**KNOXVILLE/KNOX COUNTY METROPOLITAN PLANNING COMMISSION  
CITY OF KNOXVILLE CLOSURE OF PUBLIC RIGHT-OF-WAY**

▶ **FILE #:** 8-D-13-SC

▶ **RIGHT-OF-WAY TO BE CLOSED:** Pat Head Summitt St

▶ **LOCATION:** Between Chamique Holdsclaw Drive and Andy Holt Avenue

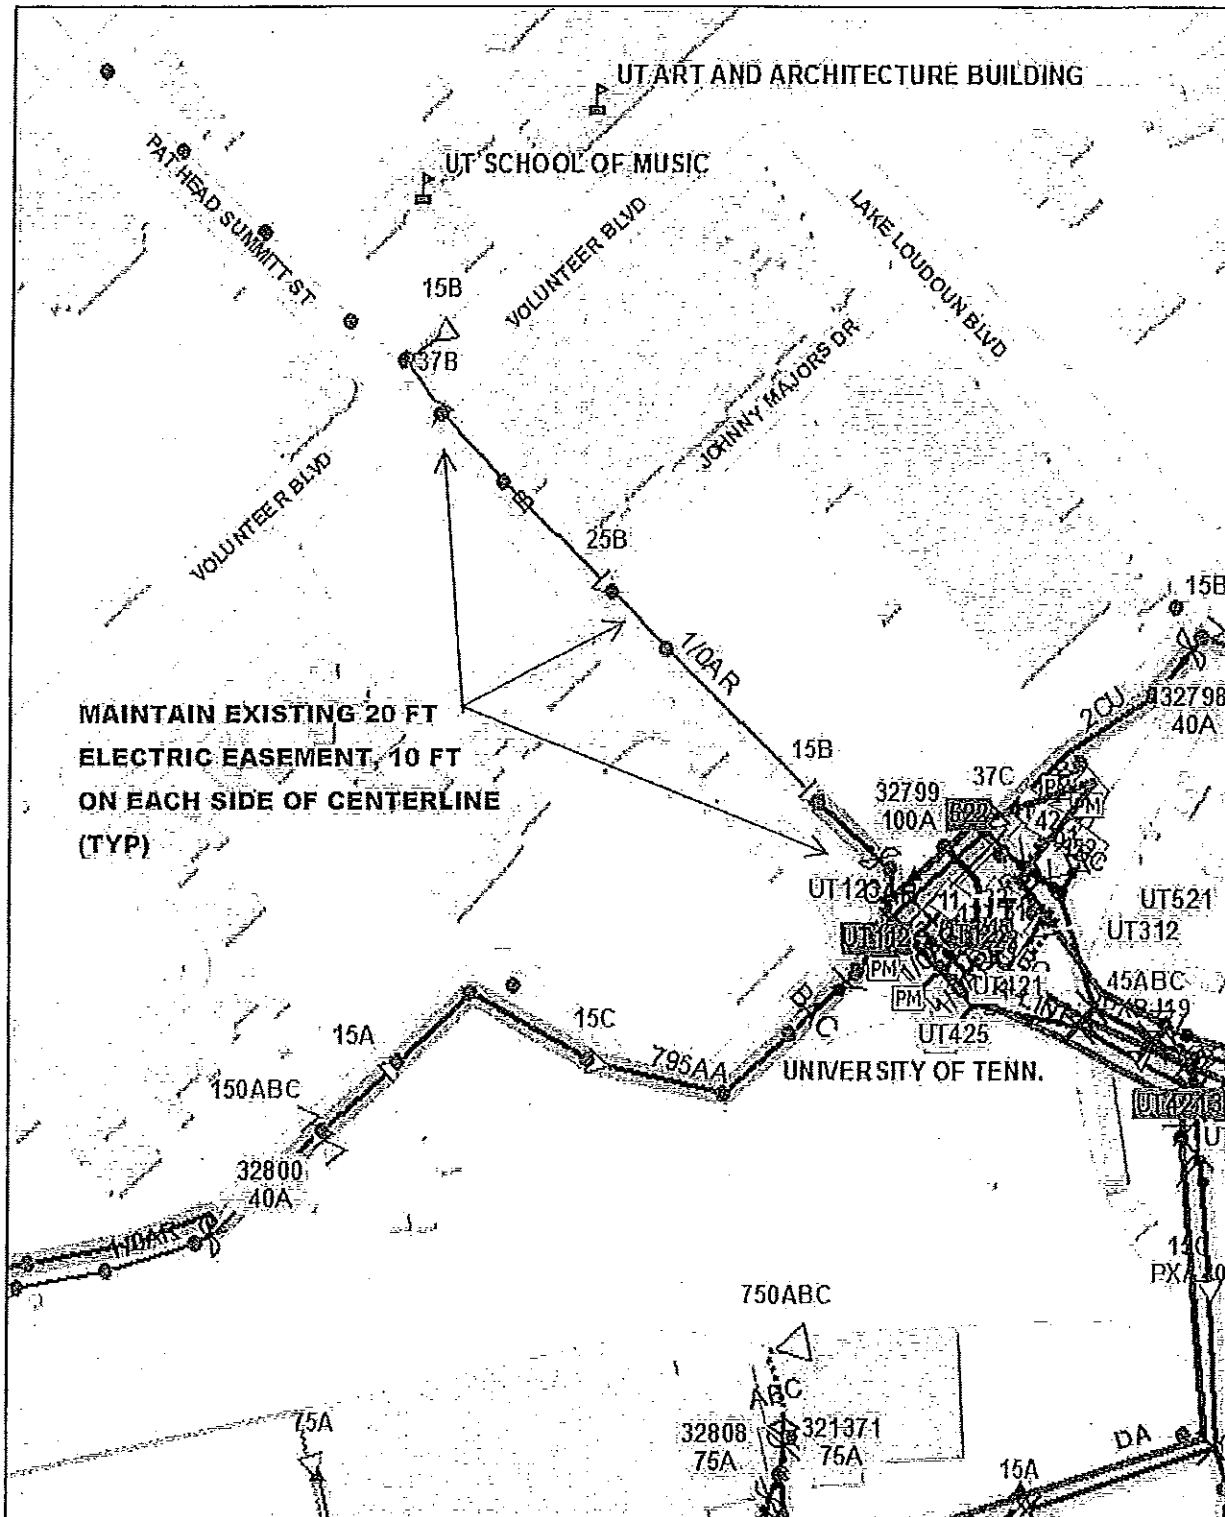
We have reviewed our records and find that we have existing utility facilities located within the subject right-of-way. The approximate location of these facilities is indicated on the enclosed prints. However, KUB does not release and hereby retains all easements and rights for existing utility facilities, whether or not shown on these prints.

Should this right-of-way be closed, KUB will require the following permanent easement for its utility facility.

Electric – 10 feet on each side of the centerline of the electric line, 20 feet total width  
Gas – 7.5 feet on each side of the centerline of the gas line, 15 feet total width  
Sewer – 7.5 feet on each side of the centerline of the wastewater line, 15 feet total width  
Water – 7.5 feet on each side of the centerline of the water line, 15 feet total width
